Detailed First Office Action

Applicant(s)	NEC Corporation	Issuing Date: September 26, 2003
Patent Agent(s)	Haibo ZHU	
Application No.	01110503.8	
Title of Invention	Multi-Path Detecting Circuit and System

THE FIRST OFFICE ACTION

图 7

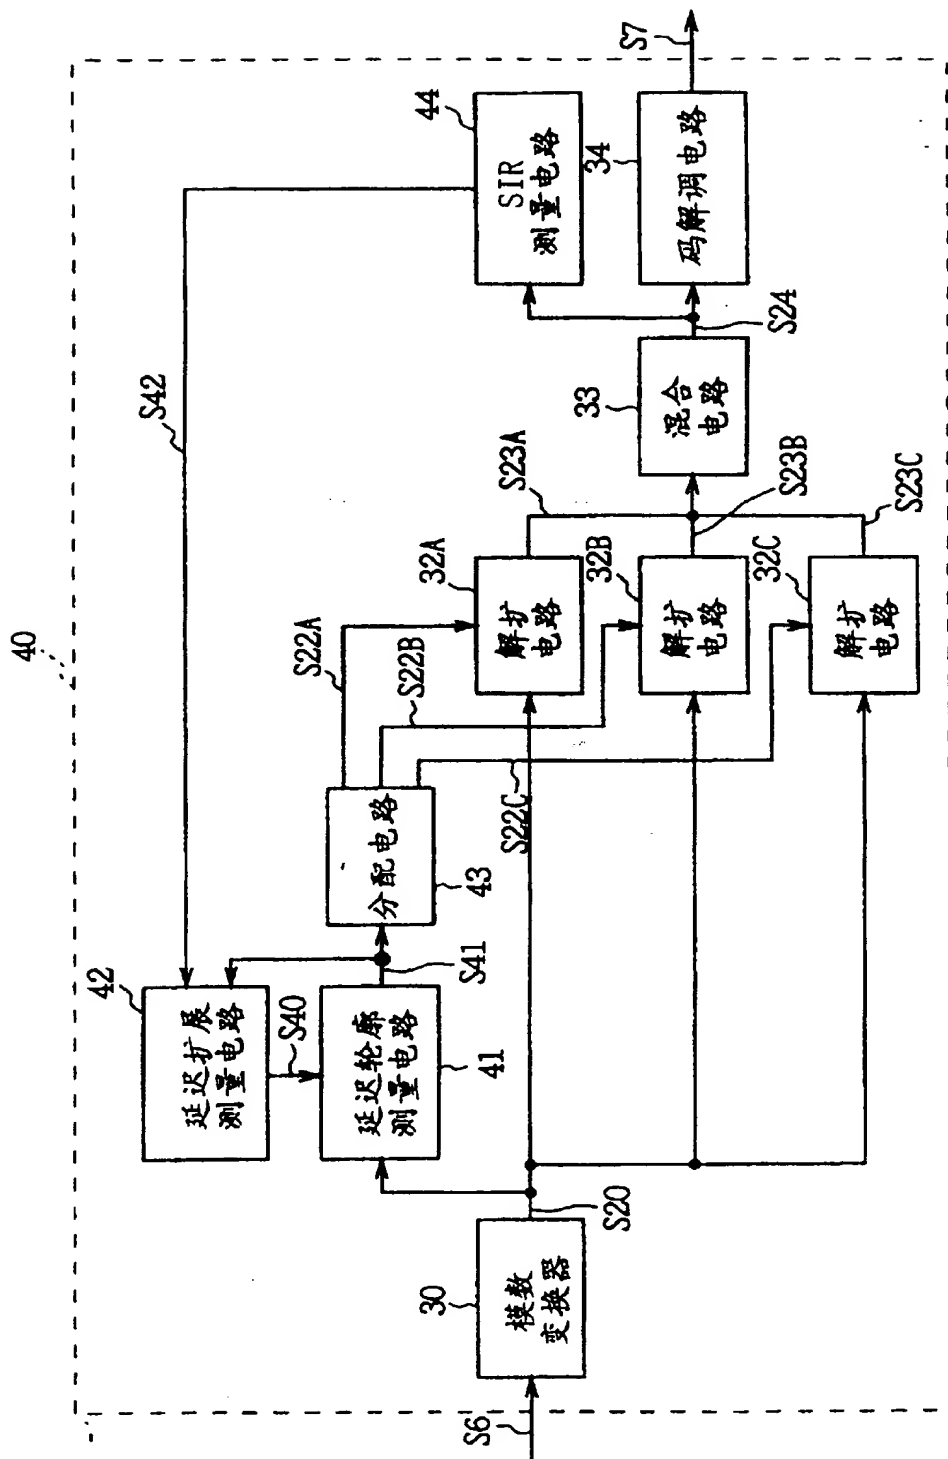
3、权利要求 7 不具备创造性,不符合专利法第二十二条第三款的规定。对比文件 1 公开了一种应用于 CDMA 系统具有路径检测功能的接收机电路的路径检测系统,并具体公开了以下的技术特征“通过平均延迟序列来确定分配给 RAKE 指状部分的路径”(参见该对比文件 1 说明书摘要、摘要附图);对比文件 2 公开了一种应用于 CDMA 通信系统的延迟轮廓检测装置电路,并具体公开了以下的技术特征“通过改变检测基带信号延迟轮廓的检测时间(即检测周期)来测量基带信号的延迟轮廓(即延迟分布)”(参见该对比文件 2 说明书第 7 页 25 行至第 8 页 27 行、说明书摘要及附图 7)。由此可见,对比文件 1 和对比文件 2 已经披露了该权利要求的全部技术特征。由于对比文件所公开的技术方案与该权利要求所要求保护的技术方案属于同一技术领域,在对比文件 1 的基础上结合对比文件 2 得出该权利要求所要求保护的技术方案,对所述技术领域的技术人员来说是显而易见的,而且两者的结合没有产生预料不到的技术效果,因此该权利要求 7 不具备突出的实质性特点和显著的进步,因而不具备创造性。

并具体公开了以下的技术特征“通过改变检测基带信号延迟轮廓的检测时间(即检测周期)来测量基带信号的延迟轮廓(即延迟分布)”(参见该对比文件 2 说明书第 7 页 25 行至第 8 页 27 行、说明书摘要及附图 7)。由此可见,对比文件 1 和对比文件 2 已经披露了该权利要求的全部技术特征。由于对比文件所公开的技术方案与该权利要求所要求保护的技术方案属于同一技术领域,在对比文件 1 的基础上结合对比文件 2 得出该权利要求所要求保护的技术方案,对所述技术领域的技术人员来说是显而易见的,而且两者的结合没有产生预料不到的技术效果,因此该权利要求 11 不具备突出的实质性特点和显著的进步,因而不具备创造性。
